## STAFF REPORT AND NOTICE OF DECISION

### Tri-Mountain Station North

File No. PLZ-21-0068-0071, 0095

**Figure 2: Site Plan**

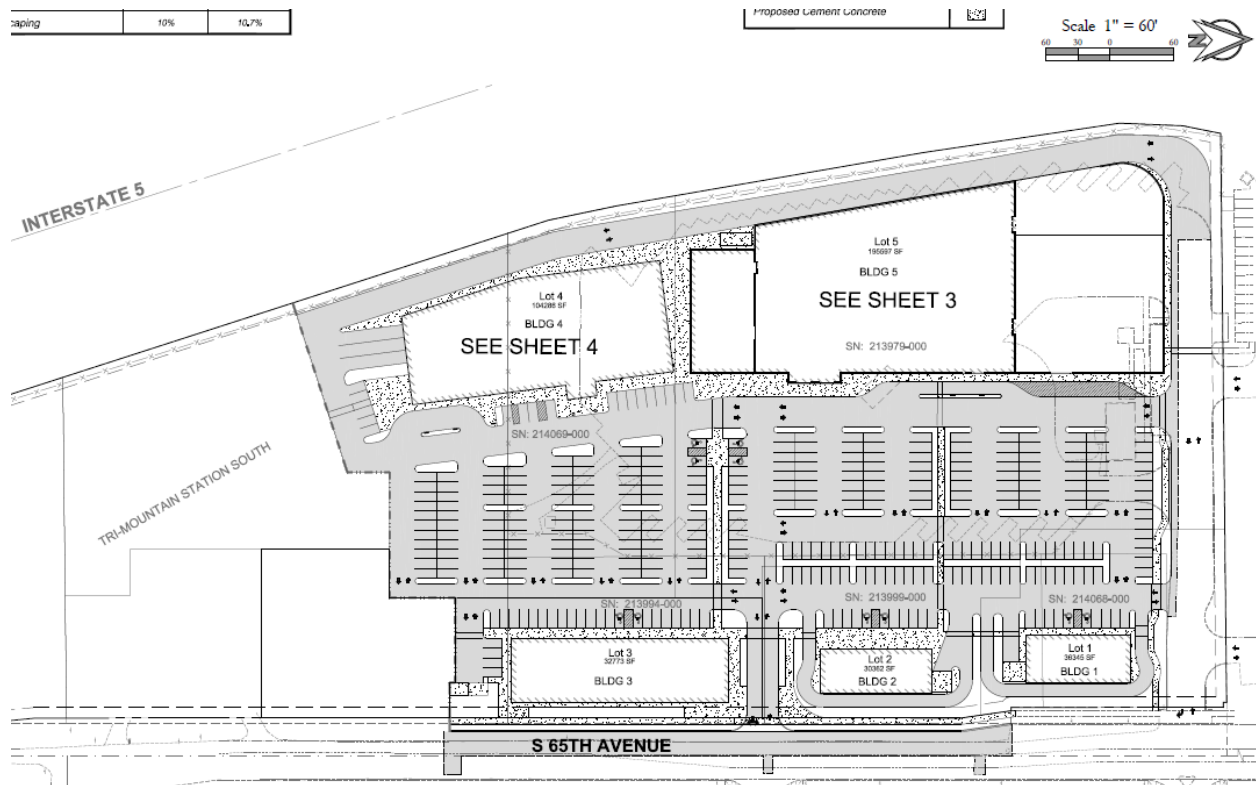
- Street frontage. S 65<sup>th</sup> Avenue, a collector, is classified as a pedestrian street in RDC 18.230.050. Buildings and common open space are provided within required street setbacks along 519 feet of the 638 feet of qualifying frontage, or 81 percent.

- Pedestrian connectivity. Each of the proposed buildings provides access from the main entrance to the street via pedestrian paths. There are four pedestrian connections to the street serving the three buildings adjacent to S 65<sup>th</sup> Avenue. There are three pedestrian pathways crossing the site that provide connectivity to the two retail buildings in the western portion of the site.

Commercial parking lot design. Parking areas are located internal to the development and do not extend into the maximum street setback. The design is intended to optimize vehicle and pedestrian circulation and safety. Parking area landscaping equal to 10.7 percent of the net parking area is proposed, and parking islands are provided to separate clusters of twenty parking spaces.

Screening and buffering. A 10-foot, L2 landscape buffer is proposed between the site and S 65<sup>th</sup> Avenue, except where enhanced drive-through buffering is required per RDC 18.230.050.H.9. A 15-foot, L5 buffer is required between the site and Interstate 5. The applicant has requested an administrative adjustment to reduce the width to twelve feet; see Section IV.J.

The applicant proposes to reduce the width of the required landscape buffer between the site and Interstate 5 from fifteen feet to twelve feet, or twenty percent, while maintaining the required plantings. The justification provided is that the portion of the site adjacent to Interstate 5 must accommodate a road that is adequately wide for delivery truck and emergency access. A purpose of the freeway landscape buffer is to provide a uniform landscaping style along the entrance to the City that obscures the view of the freeway for site users and obscures service roads, storage areas, and other back-of-site business from drivers approaching the City. Therefore, enhanced planting will be required to compensate for a narrower buffer width

- Prior to engineering approval, the applicant shall demonstrate that internal and external pedestrian connections are a minimum of five feet wide. (RDC 18.230.050.D.4.c)
- Prior to engineering approval, the applicant shall demonstrate that internal and external pedestrian connections are accented with landscape buffers a minimum of five feet wide including trees a minimum of every 25 feet, shrubs at the rate of one per 20 square feet of landscaped area, and groundcover sufficient to provide at least 85 percent coverage of the landscaped area. The required landscaping shall be installed prior to final occupancy. (RDC 18.230.050.D.4.e)

- Prior to engineering approval, the applicant shall update the landscape plans to show an enhanced L5 buffer along the western site boundary, including understory trees at an interval closer than 8 feet, shrubs, or a similar measure approved by the Community Development Director.
